Our ref: MP08_0150-PA-46

Subject: Appin Mine Extraction Plan: Longwalls 709-711 & 905 for Bulli Seam Operations Project (Condition 5, Schedule 3 of consent MP 08_0150)

**BULLI SEAM OPERATIONS PROJECT (MP 08_0150)
APPIN MINE EXTRACTION PLAN: LWs 709 – 711 & LW 905
Reasons for Approval**

Figure 1: Extraction Plan Longwall Layout and Study Area

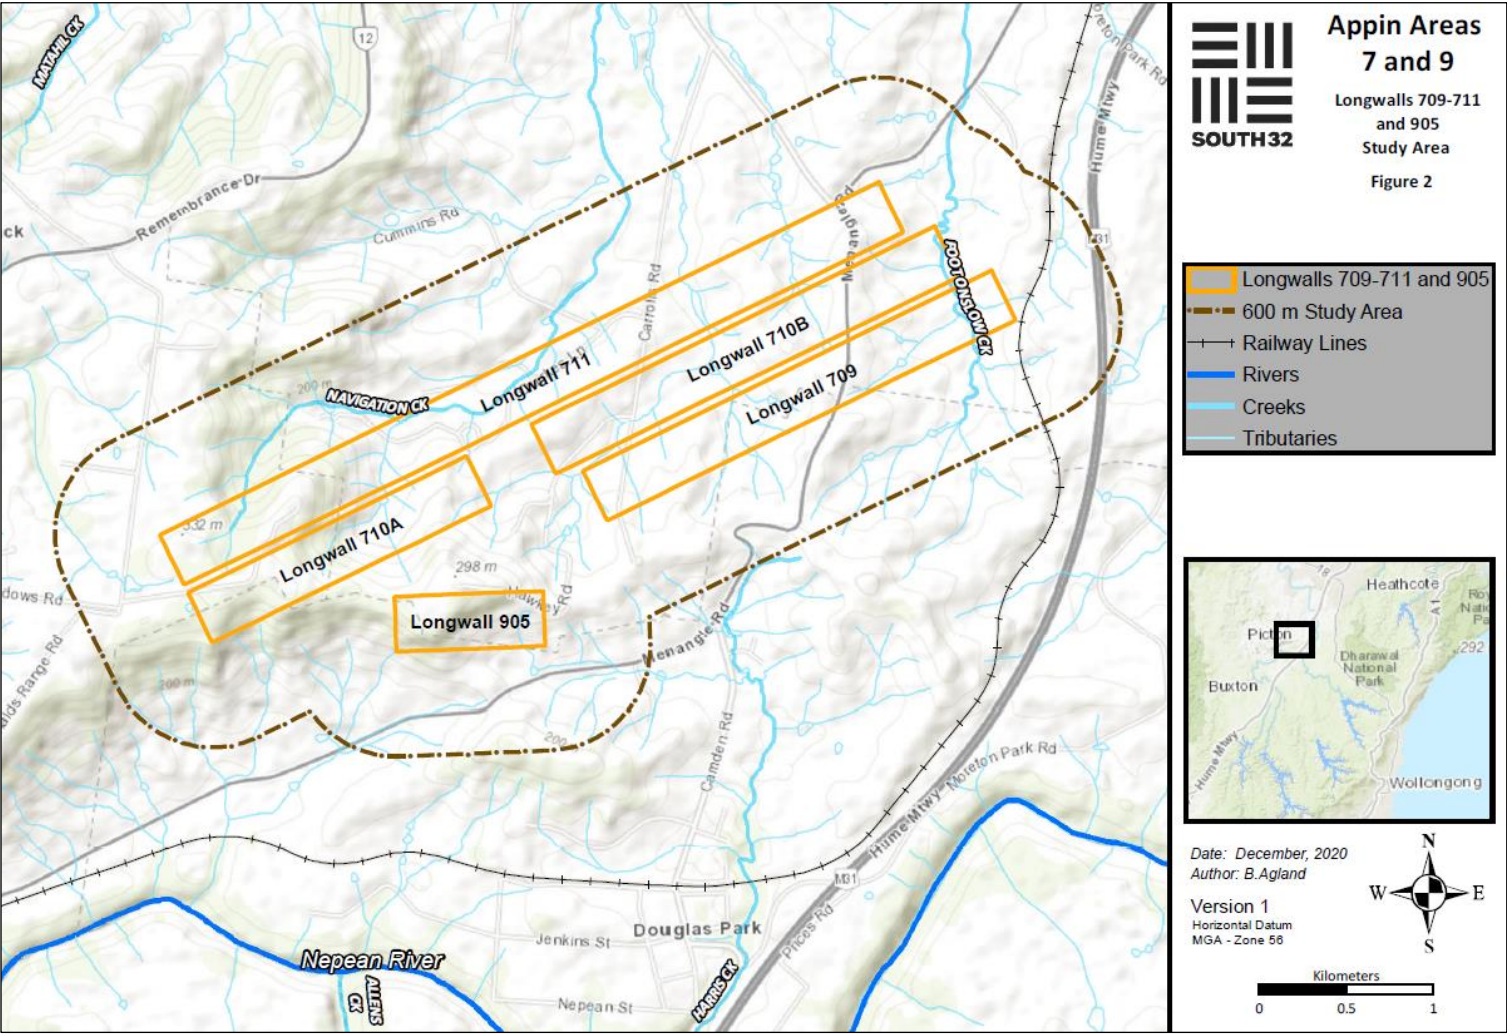
In October 2021, IMC submitted an Extraction Plan for longwalls (LWs) 709 – 711 & 905 (**Figure 1, Attachment 1**). The Extraction Plan is supported by associated management plans (MPs) and technical assessments.

The Department notes that IMC has mostly shortened the longwalls to increase setbacks from the Nepean River and the cliffs. LW711 has been extended in length and joined with an approved but shorter longwall from Area 9 to optimise resource recovery.
